MEMORANDUM FOR THE EXECUTIVE SECRETARY, SURVEY
APPLICATIONS COORDINATING COMMITTEESUBJECT: Review of Goddard Space Flight Center Specification for
Two-inch Return Beam Vidicon Camera System

MEMORANDUM FOR: Mr. John E. Kirk
DOD Co-Chairman, SACCSUBJECT: Work Statement for Test Engineering Model of a
Two-inch Return Beam Vidicon Camera System

CSFC SPECIFICATION FOR
TWO-INCH RETURN BEAM
VIDICON CAMERA SYSTEM

FIGURE 1 - VIDICON FACEPLATE FORMAT

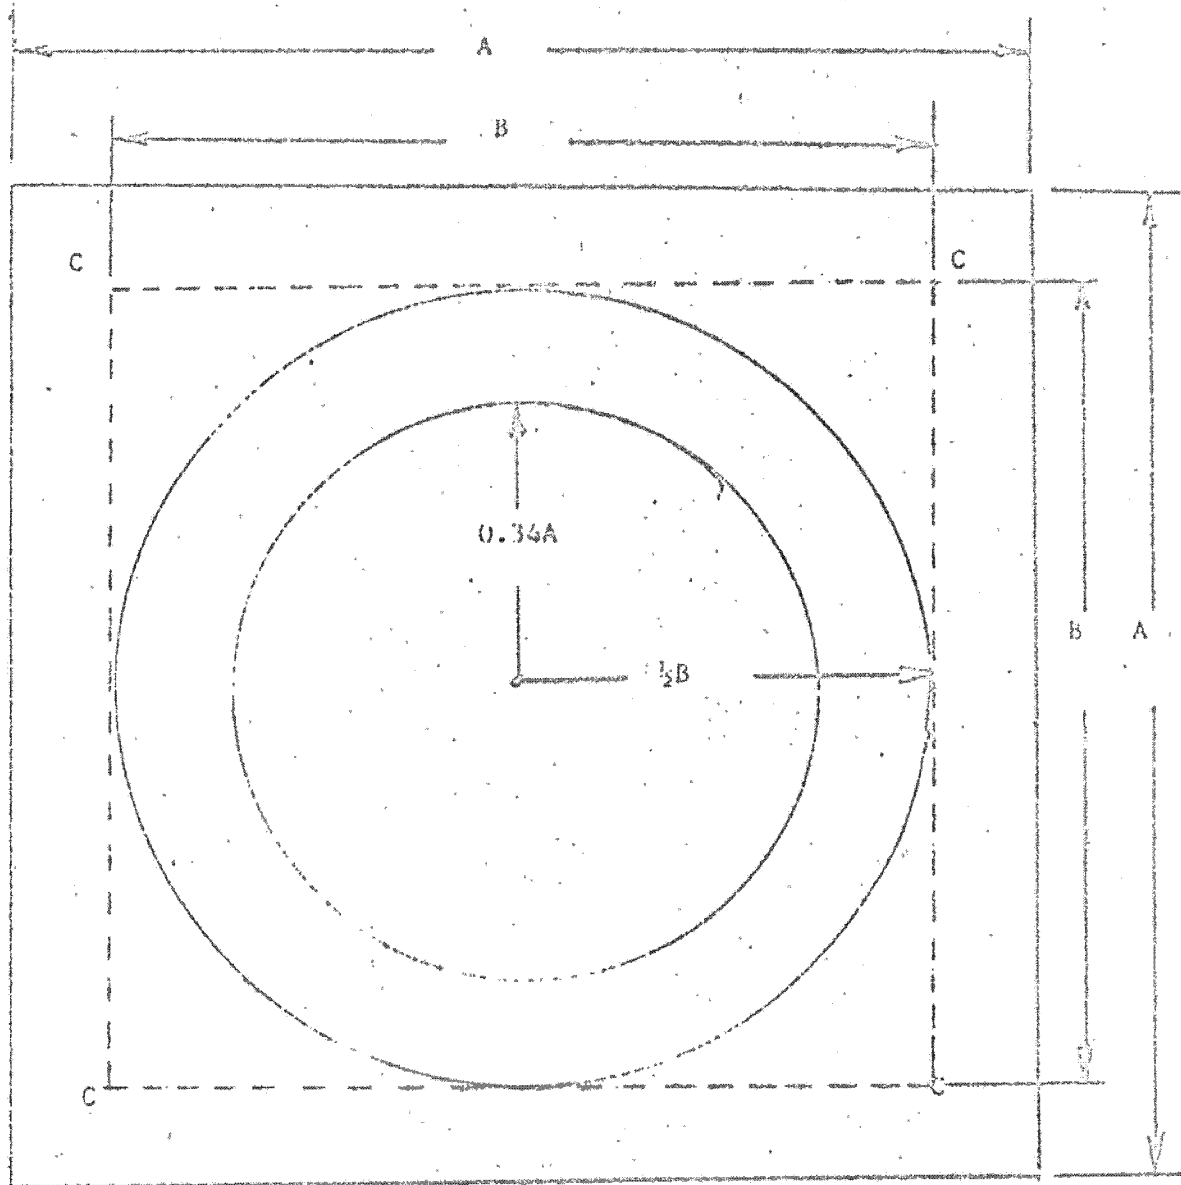
In addition, you should probably edit the ground resolution specifications in addendum paragraph 3.11.2 of the July 23, 1968 revision to S-733-P-4, which are not compatible with the theoretical capabilities of the vidicon specified in the basic document.

Attention is invited to the resolution specifications in paragraph 3.11.2 and to addendum paragraph 3.11.2 of the 23 July 1968 revision. This interprets the expected system performance in terms of the limiting ground resolution from 496 nautical miles altitude.
